# PERMIT

Tax ID #  
**ON-SITE SEWAGE DISPOSAL SYSTEM**  
**HOWARD COUNTY HEALTH DEPARTMENT**  
**BUREAU OF ENVIRONMENTAL HEALTH**

SUBDIVISION: Warfield Estates II LOT NUMBER: 31

ADDRESS: 14846 Michele Drive PROPERTY OWNER: NVR Inc.

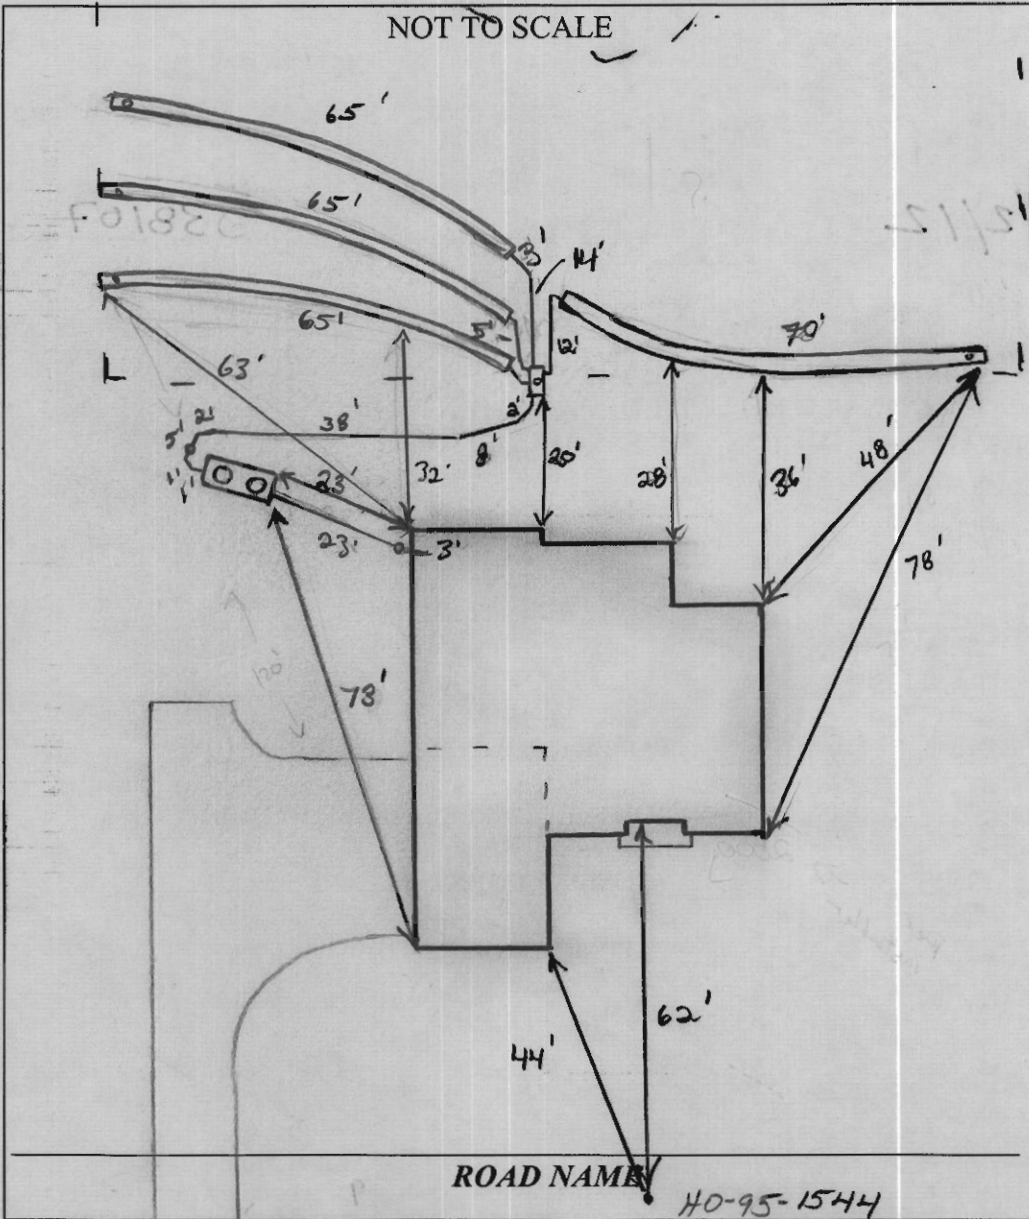
11/5/12 Approx. 3' of fill or so needs to be removed from top part of septic area. OK to set S.T. 20' from house. Trenches will start @ middle part of SRA. No contour shot (KW)

11/8/12 Fill removed. Contour very difficult. System spec's adjusted to fit system. 12" difference in spot elevation on trenches. Short grade 30' back and add 9' bottoms to hold all the way thru trenches.

INSTALLATION: should be 6" deeper @ start of trenches and 16" shallower @ ends. Call for I/V. (KW) 11/09/12 S.T. set. Nothing else started. (KW) 11/14/12 2 trenches installed. Could not verify depths. (KW) 11/15/12 3 trenches installed. OK to continue (KW) 11/16/12 system complete. OK to cover all work.
